PLANNING COMMISSION
STAFF REPORT

APPLICATION NO: Neighborhood Design Plan No. NDP-25-19. River Islands Amendments to the Community at South River Bend, East Village, Lakeside East, Lakeside West, Old River, West Village Age Restricted Neighborhoods, West Village Non-Age Restricted Neighborhoods, Lake Harbor West, & Woodlands East District Architectural Design Guidelines and Development Standards (DG/DS)

REQUEST: Planning Commission to Consider Adoption of a Resolution to Approve Amendments to the Community at South River Bend, East Village, Lakeside East, Lakeside West, Old River, West Village Age Restricted Neighborhoods, West Village Non-Age Restricted Neighborhoods, Lake Harbor West, & Woodlands East Districts Architectural Design Guidelines and Development Standards (DG/DS) for the River Islands at Lathrop.

Figure 3-4: Builder Responsibility at Rear Yards

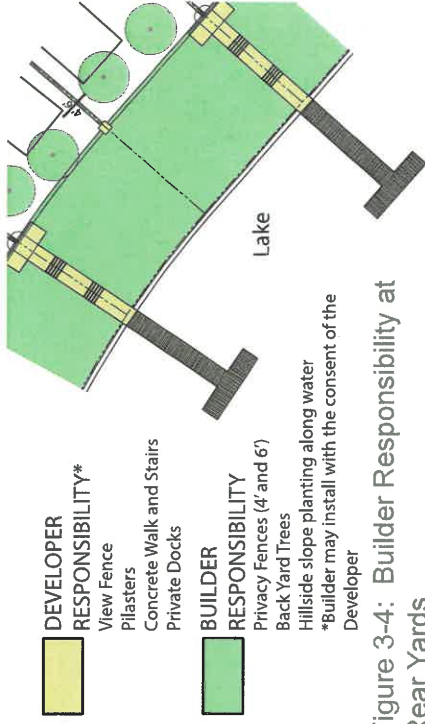
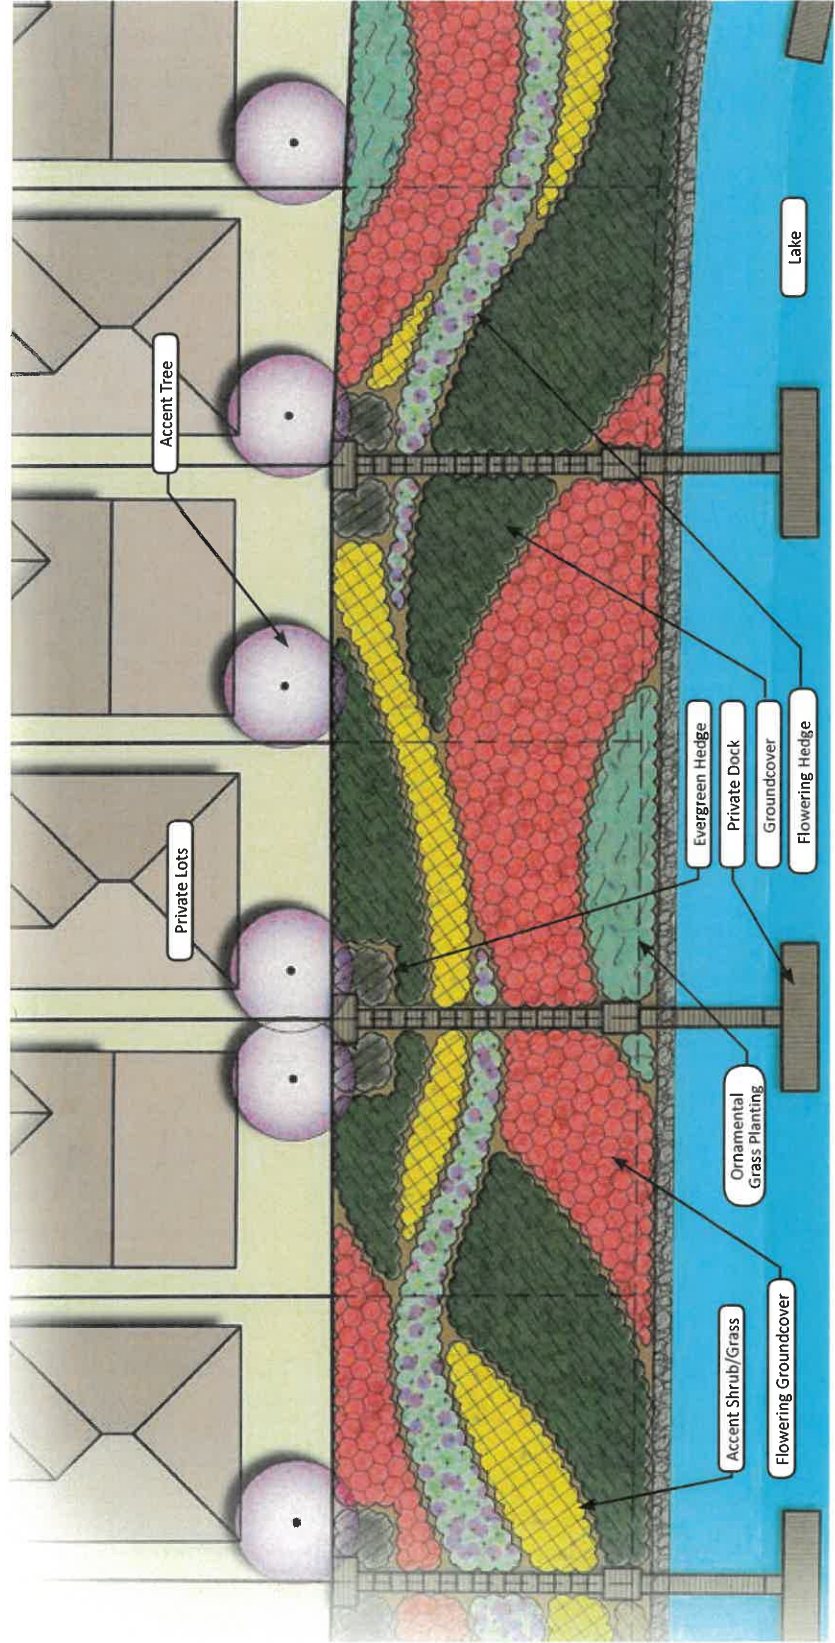
1. Areas between the homeowners' fence and the lake's edge (lake slope) shall be the responsibility of the homeowner to maintain.
2. Any proposed modifications to lake slope landscaping and irrigation shall be reviewed the relevant public agency owning the slope and by the River Islands CC&R Team prior to any changes.
